ADDENDUM #1
June 23, 2022

TO: ALL Prospective Bidders
PROJECT: N 33rd Street Transmission Main
BID REFERENCE #: 91244-020.0
BID OPENING DATE/TIME: **June 30, 2022 @ 3:30 p.m. Local Time**

N 33rd Street Transmission Main

Attachment B ***Response to Questions***

External Map Request for Jennifer

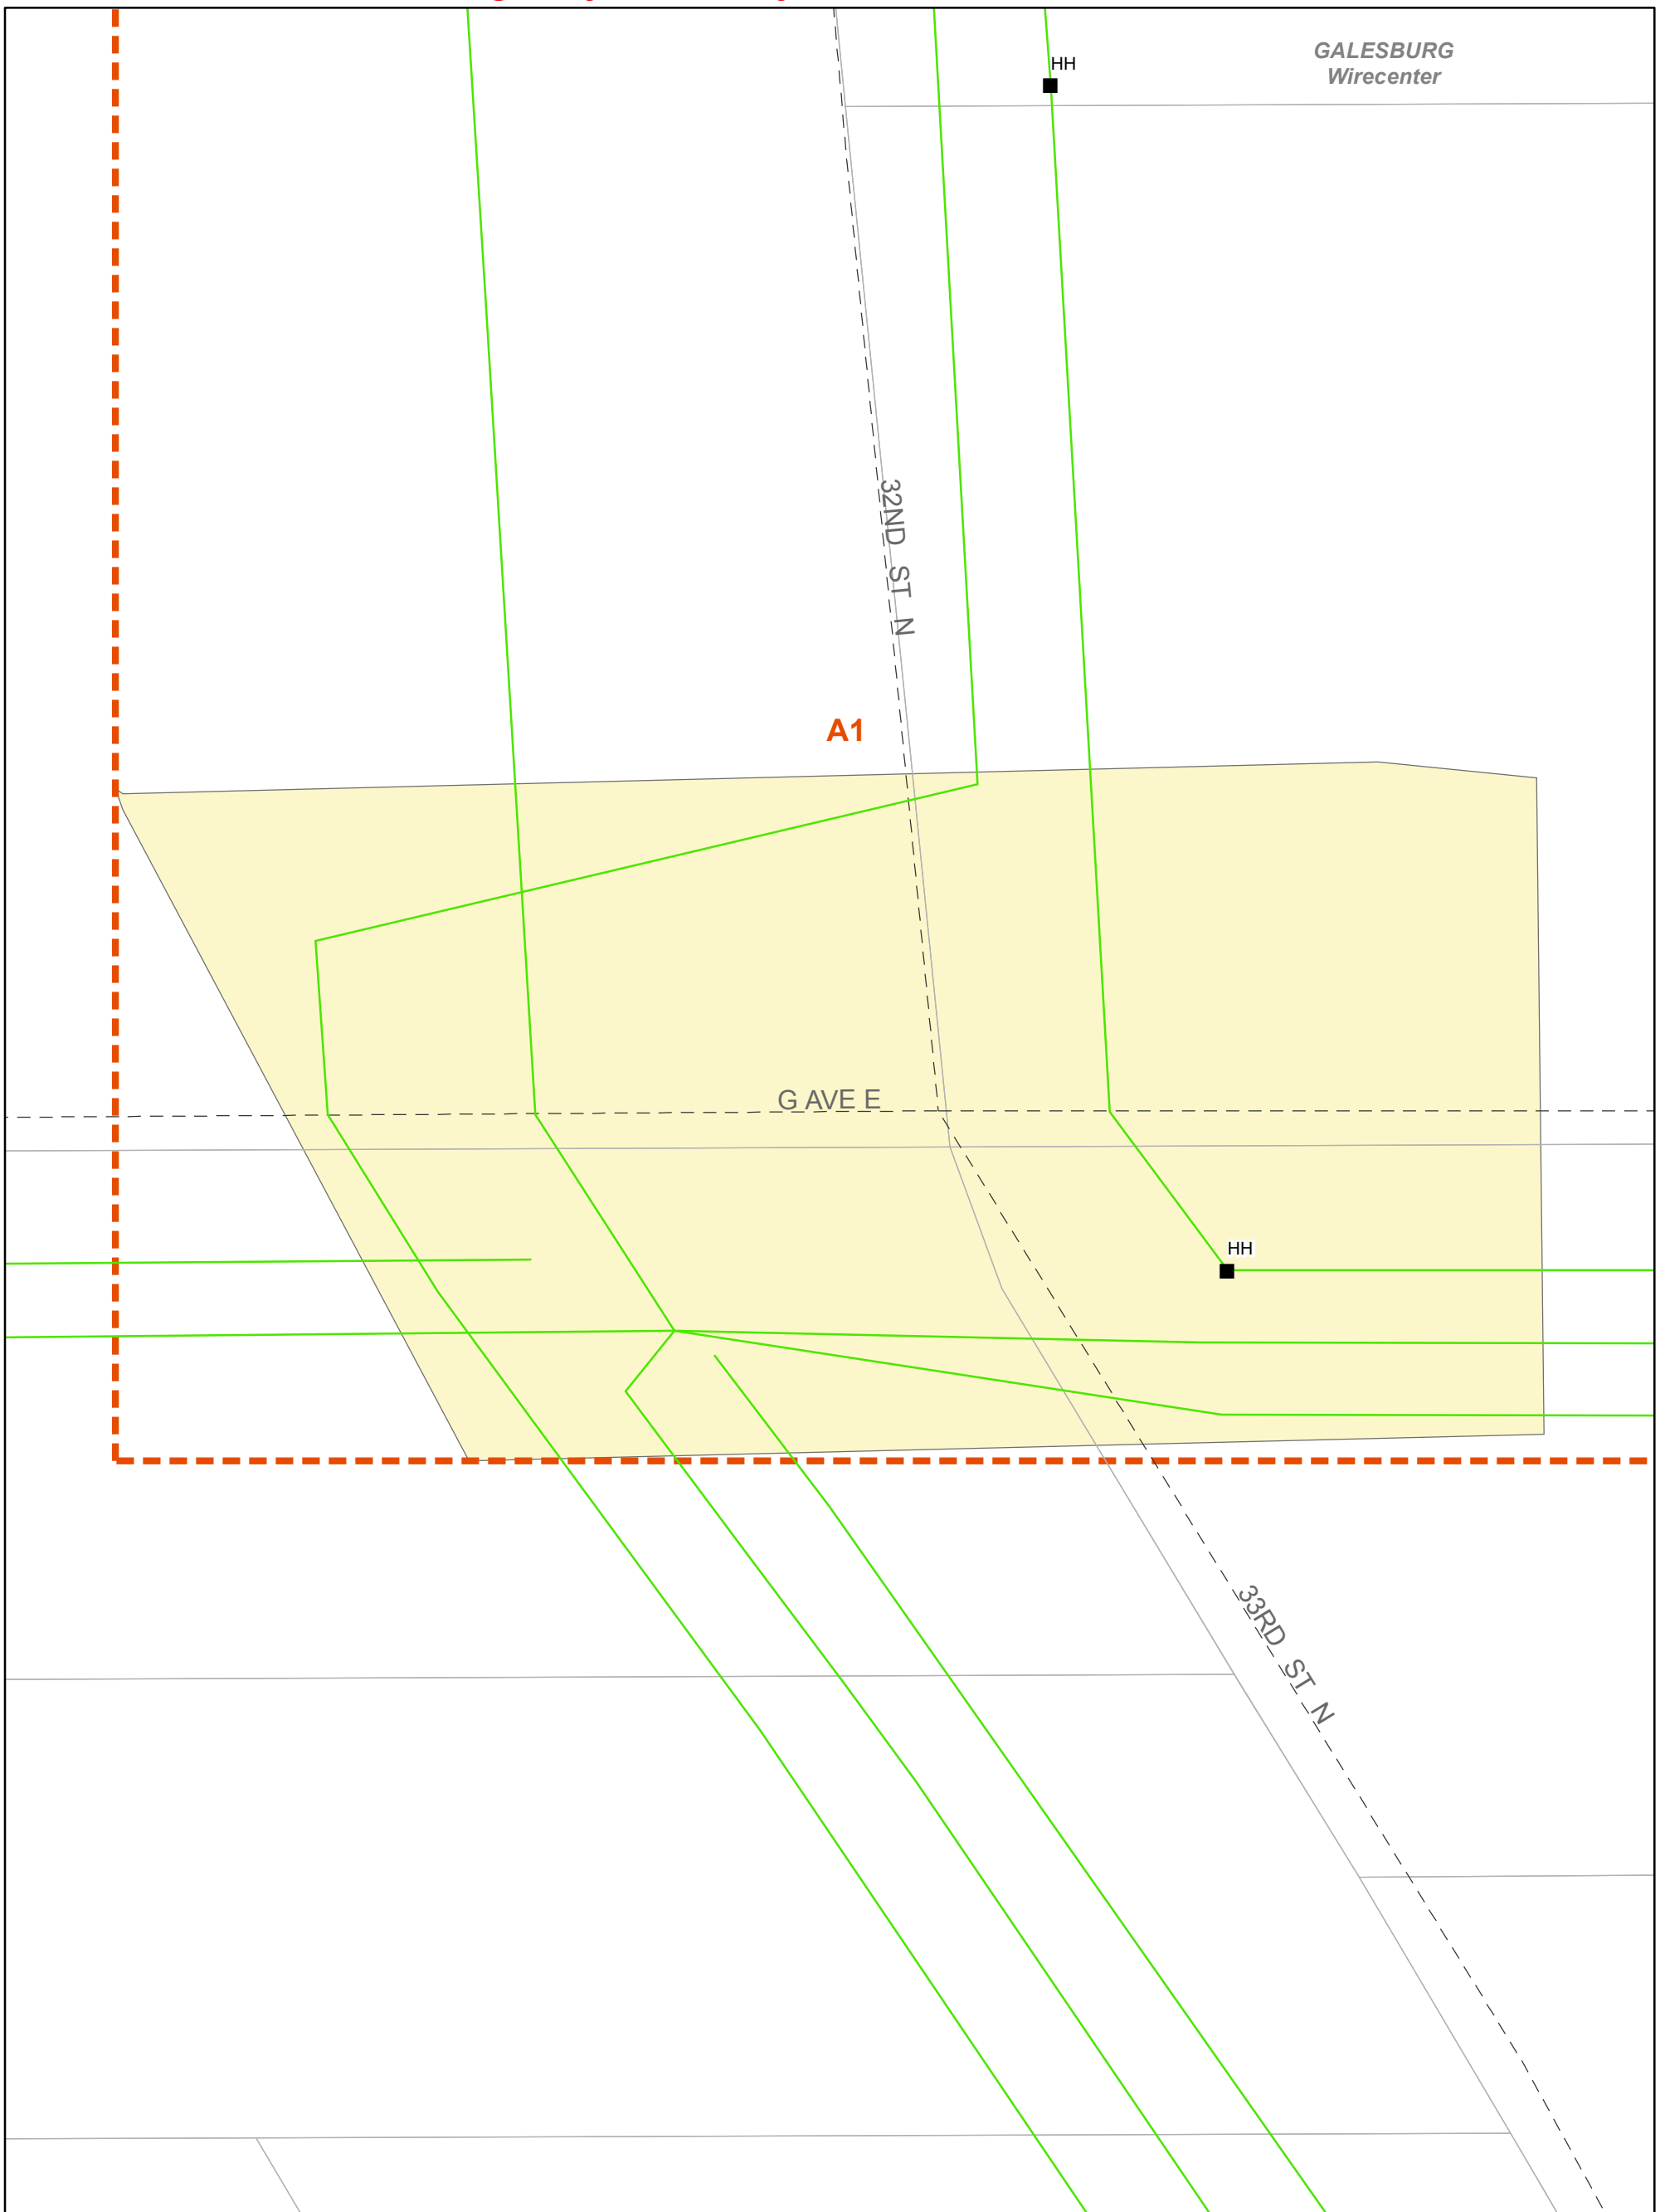
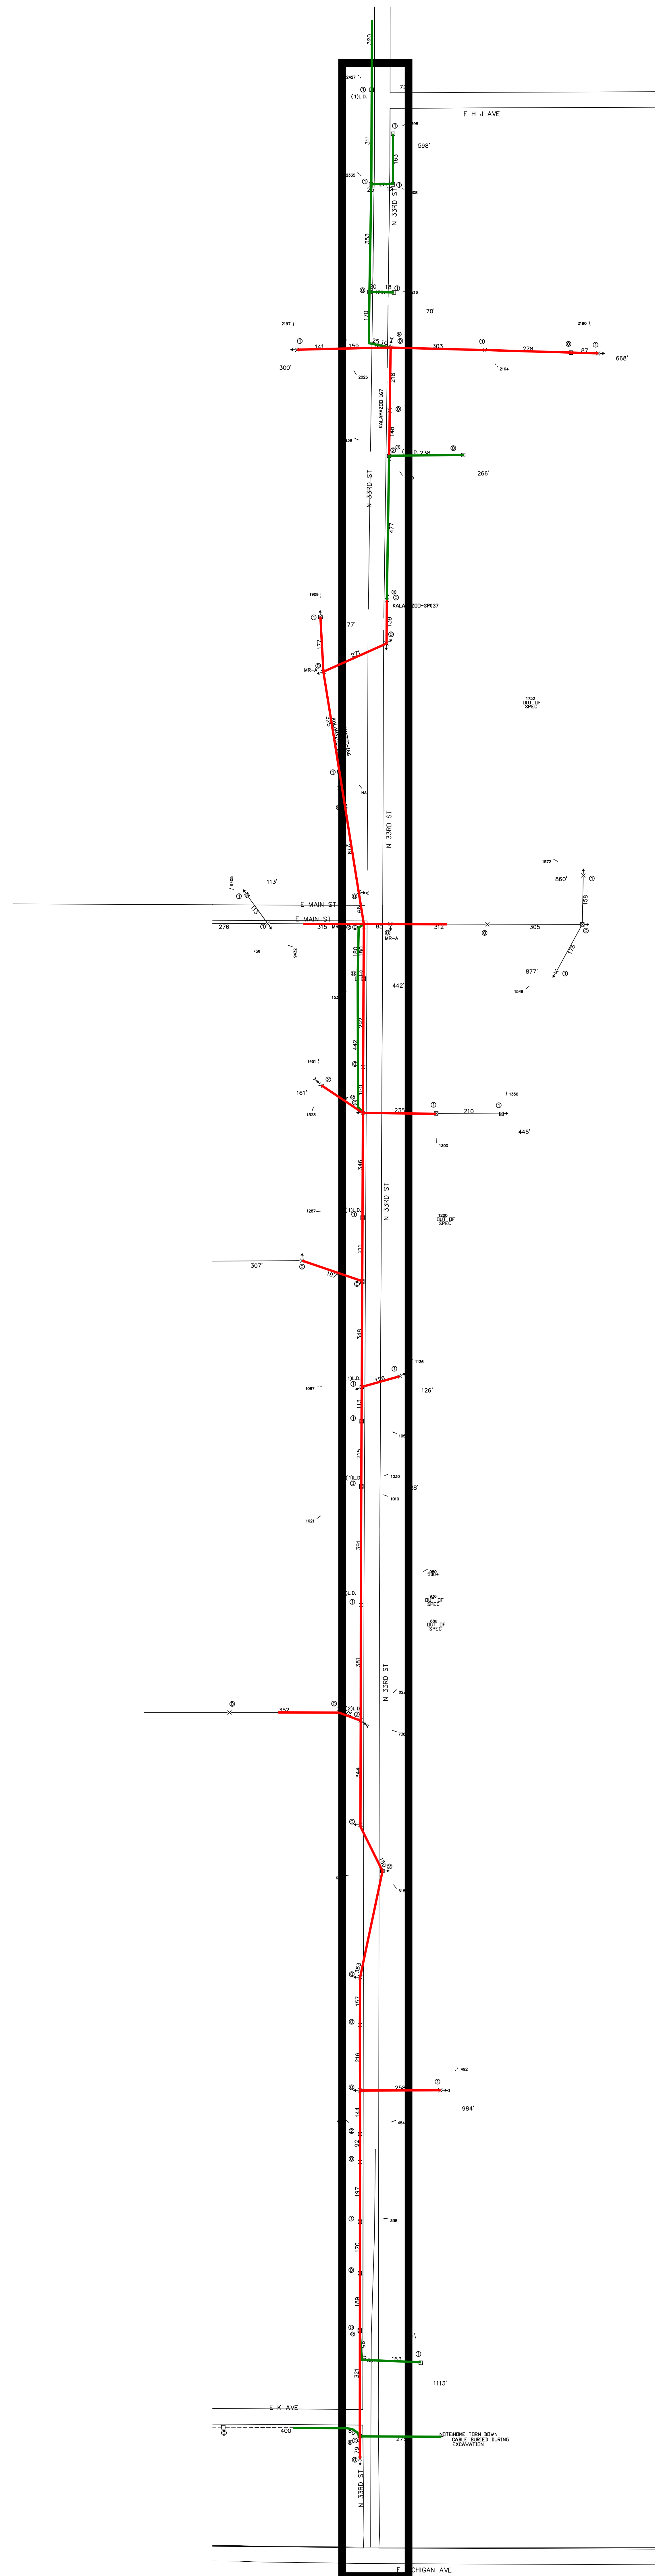
Q7: The plans show telephone pedestals throughout the project but, we are unable to locate the underground lines on the plans. The location of these lines could greatly influence construction/constructability. Please provide this information.

A: See attached MISS DIG AT&T and Charter maps obtained through a MISS DIG design ticket. The Contractor remains responsible for locating existing utilities and providing temporary support of existing utilities as required during construction.
